**Subject:** MHI's Response to US-APWR DCD RAI No. 322-1999 (60-day response)

Response to Request for Additional Information No. 322-1999,  
Revision 0 (60-day response)

**US-APWR Design Certification**

**RAI NO.:** NO. 322-1999 REVISION 0

Figure 3.8.1-8 Containment Penetrations  
(Sheet 12 of 17)

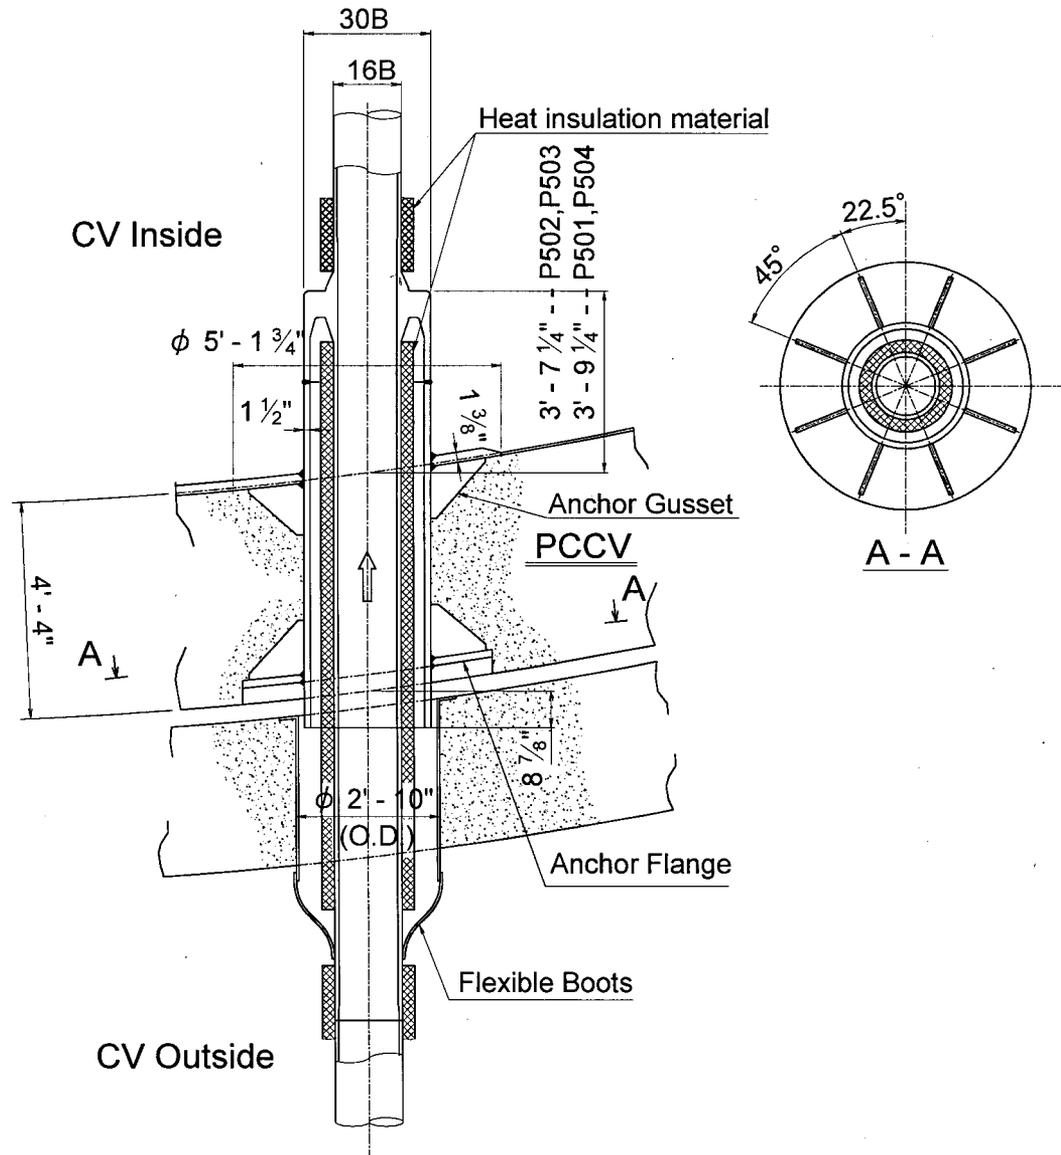
In reviewing the applicant's response to Question 06.02.06-11 dealing with containment vessel penetration cooling, concern was generated about the stress that would be placed on the in-containment penetration collar welds between the penetration sleeve and the end cap and between the end cap and the steam pipe. The penetration arrangement of concern is depicted in DCD Figure 3.8.1-8 (Sheet 12 of 16) on page 3.8-148 of the DCD. As shown, on the in-containment side of the penetration there is a full penetration weld between a thickened section of the steam pipe and the end cap (collar) and a corner weld between the penetration sleeve and the end cap (collar).

- Provide the stress analysis demonstrating the structural integrity of this weld over time for all loads and load combinations, including the effects of induced steam flow vibrational movements in the steam piping, and any other piping loads imposed on the penetration assembly. Also, provide the inspections and nondestructive tests to be performed on these welds to meet code requirements. In addition, confirm that the function of these welds is to provide the containment barrier leak tightness and structural support of the steam piping.

Welds located between the inner side of flat heads and pipes of PCCV penetrations for high-energy fluid system piping, main steam piping, feedwater piping, and SG blow down piping; do not satisfy the criterion of BTP 3-4, Part B, Item A(ii)(5).

These penetrations are modified with welded attachments to the flued head structure to satisfy the criterion of BTP 3-4, Part B, Item A(ii)(5) as shown in Figure 3.8.1-8 (Sheet 12 of 17) in MUAP-09003 (R0), US-APWR DCD RAI Tracking Report. See Figure 3.8.1-8 (Sheets 12, 13, and 14 of 17) below.

Figure 3.8.1-8 Containment Penetrations  
(Sheet 13 of 17)

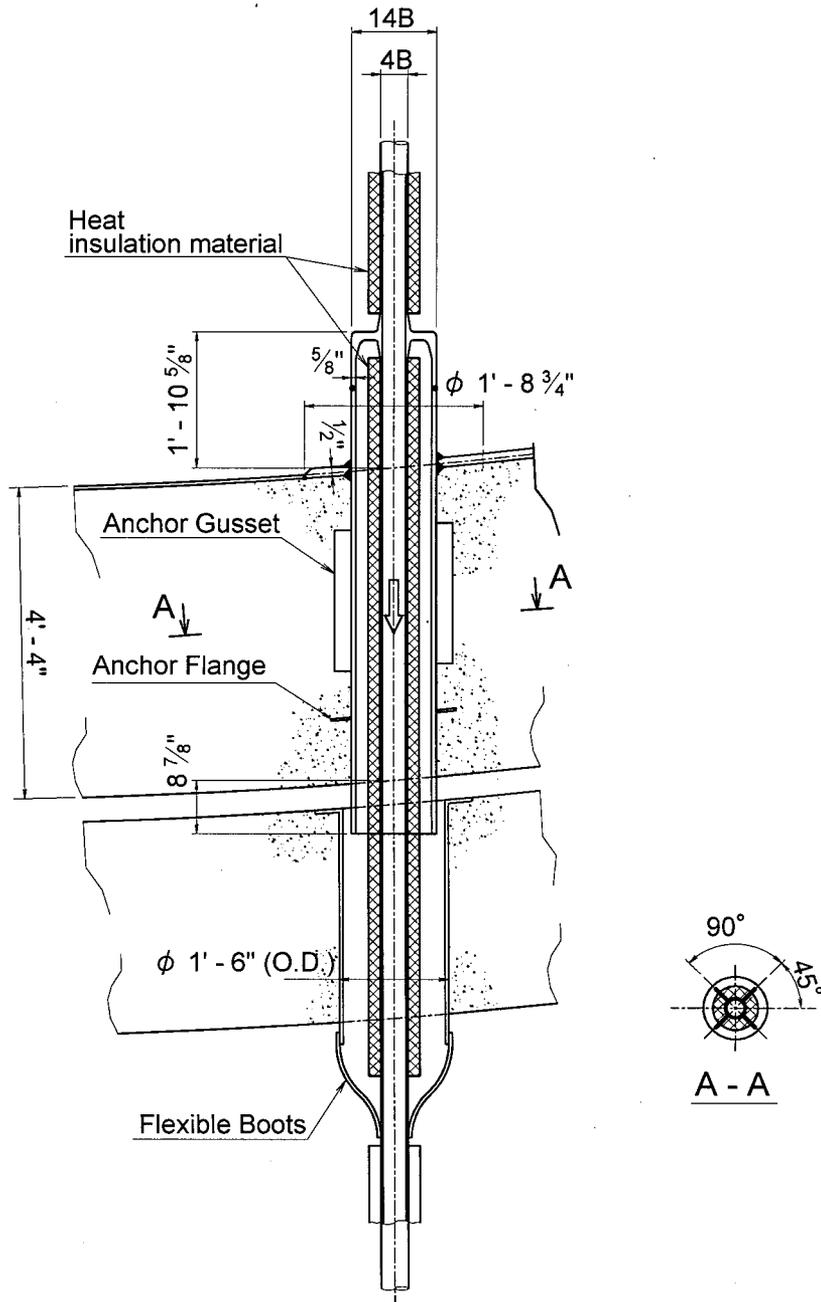
It is noted further that the weld details (i.e., between the penetration sleeves and the end caps and between the end cap and the piping) used in penetrations for the main steam lines, are also used for other major penetrations, including the Feedwater piping (DCD Figure 3.8.1-8, Sheet 13 of 16), and the SG Blowdown piping (DCD Figure 3.8.1-8, Sheet 14 of 16).

- Provide the stress analysis for these other major piping penetrations for all loads and load combinations, (including Feedwater piping and SG Blowdown piping), taking into account the piping loads imposed on the penetration assembly, thermal effects, and any dynamic loads anticipated from the piping systems in these penetrations.
-
